LFM-0122-200-166

ReportNumber: 01											_	ProjectNumber:												_	LFM-0122-200-166							
			FM-0122-200-166								_	InquiryNumber:													LFM-0122-200-166.001							
				0-01								_	DrawingNumber:												_	LFM-0122-200-166.idw						
PartTitle: Turk			rbine blade							_	Visual testing date:												_(05.04.2	2022							
												Te	est	tin	g i	inf	or	m	at	io	n											
Test standards: DI			DIN EN 13018										Printing process/ machine:											ne		FDM (metal)/ Makerbot Method X						
Test instruction	on:	-	in	internal									_	Printing specifications:												_	-					
			100%										Acceptance rule:												i	internal						
																_														_		
Test device:		-								lipe	er			_			esti					J.						_	Lamp, Camera, Lens			
Illuminance m				Voltcraft LX-10 1662853									-		LU	ו או	me	245	sur	ec	J.						_	455				
Measuring de	vice n	···	Т.	002	203	03								_

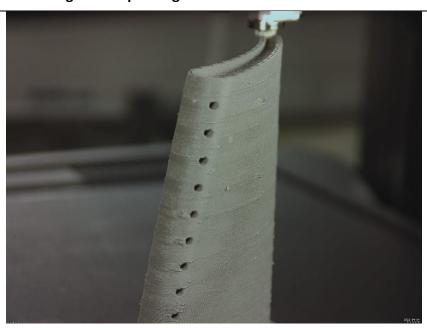
Raft difficult to remove

General view immediately after printing

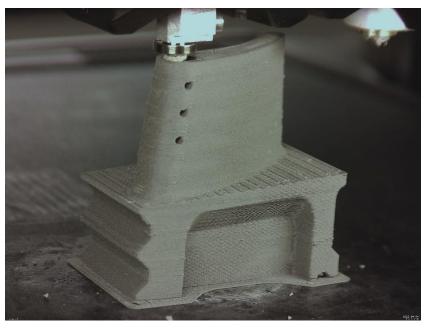
View under test conditions	
View of the defects (if occurred)	
Blobs

Bad initial layer due to difficult raft removal	
Rough surfaces
